# "TIMBERWOLF ADDITION"

RE: S/D 99-72 -- One-Step Final Plat of TIMBERWOLF ADDITION

**STAFF REPORT**  
(One Step Final Plat Approved 11/18/99)

**CASE NUMBER:** S/D 99-72 -- TIMBERWOLF ADDITION

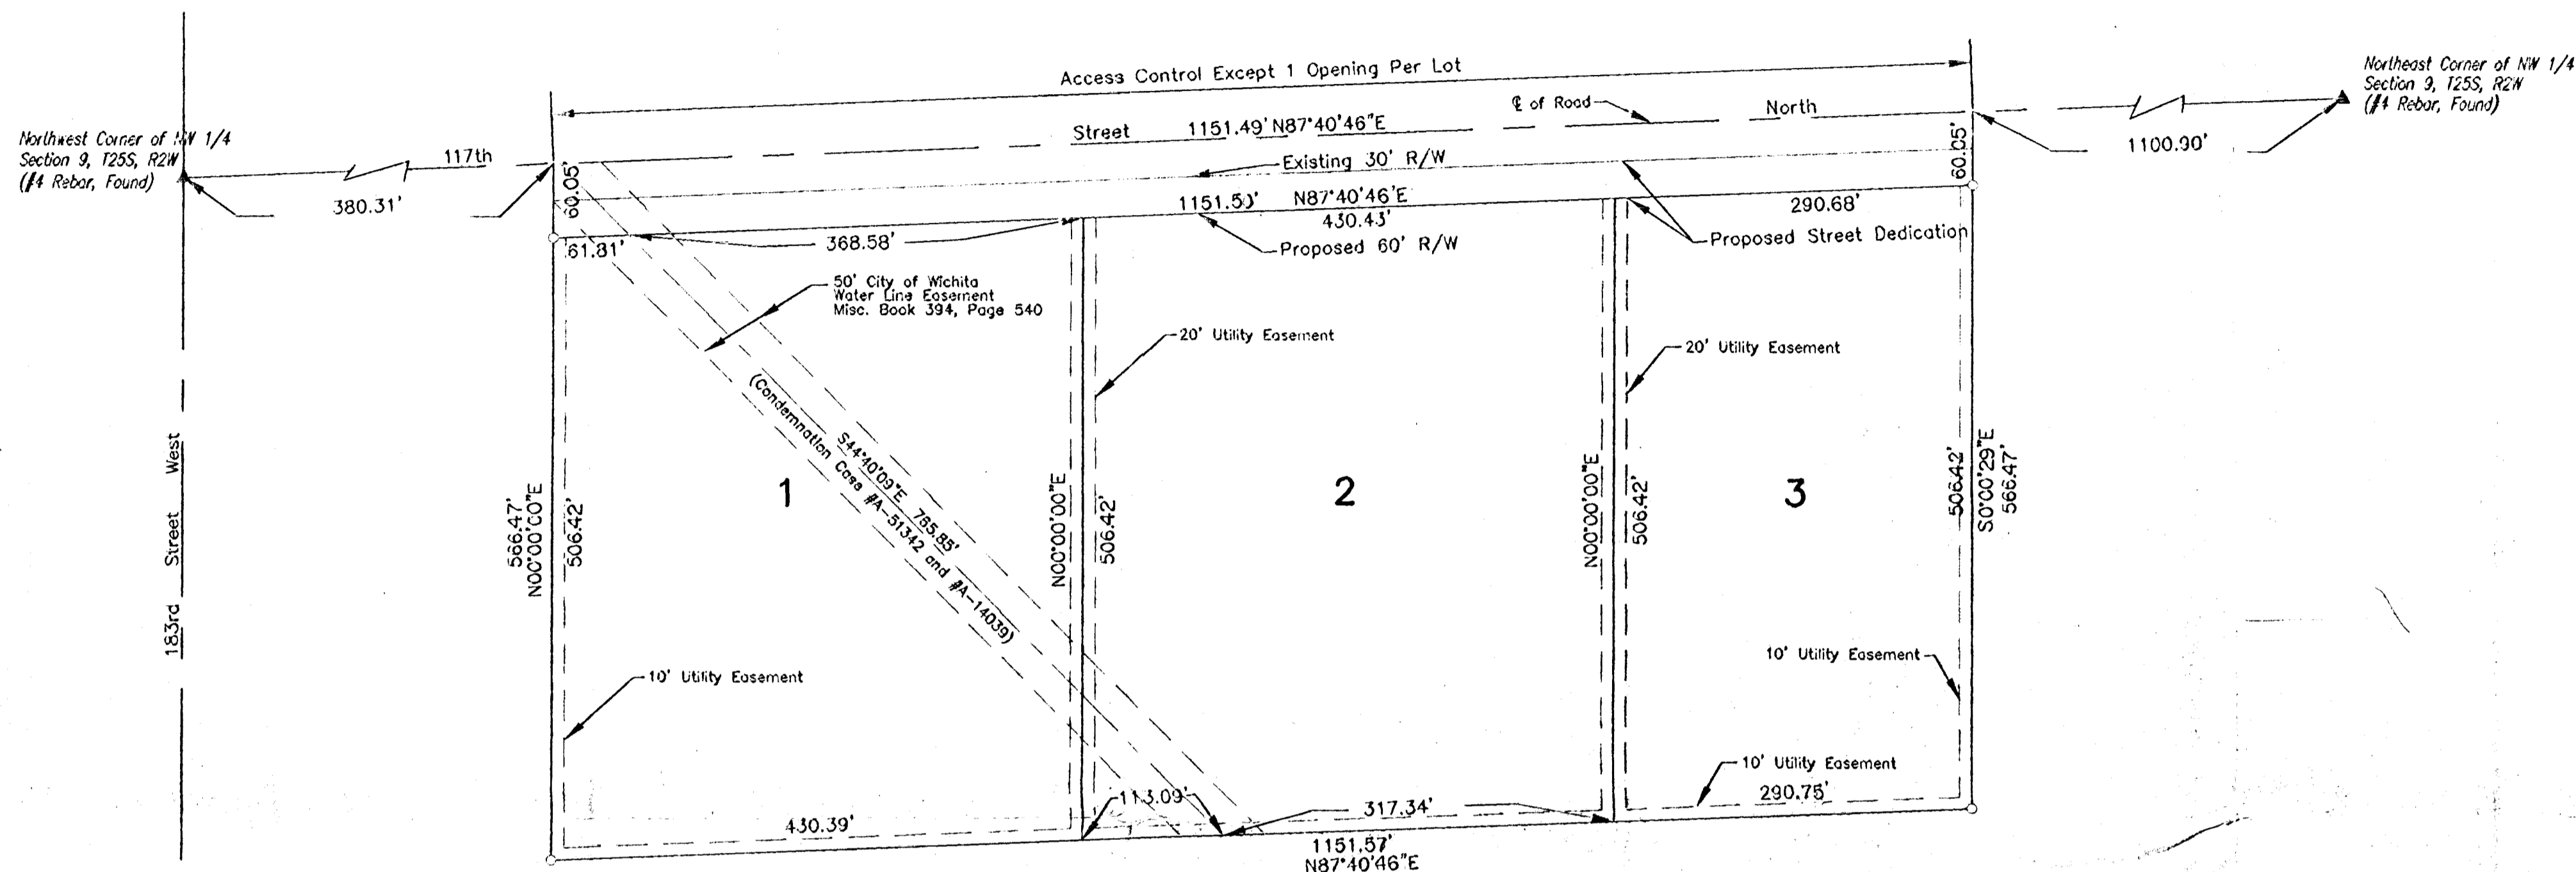
- B. Bearings and recording data need to be added for the water line easement. Bearings and distances need to be added for all lot lines.
- C. **County Engineering** needs to comment on the status of the applicant's drainage plan. **The drainage plan is approved. Utility easements need to be added between the lots and along the perimeter.**

- D. The Applicant proposes to dedicate access control except for one opening per lot along 117<sup>th</sup> St. North. The face of the plat shall be revised to reference "one opening per lot". The plat's text shall note that the access controls are being dedicated to the appropriate governing body.

- E. The MAPC Chair should be revised to reference "Francis S. Garofalo".

- F. The County Commissioners signature block only requires the signature of Bill Hancock.
- G. The plat's text shall include language that a drainage plan has been developed for the plat and that all drainage easements, rights-of-way, or reserves shall remain at established grades or as modified with the approval of the applicable City or County Engineer, and unobstructed to allow for the conveyance of stormwater.
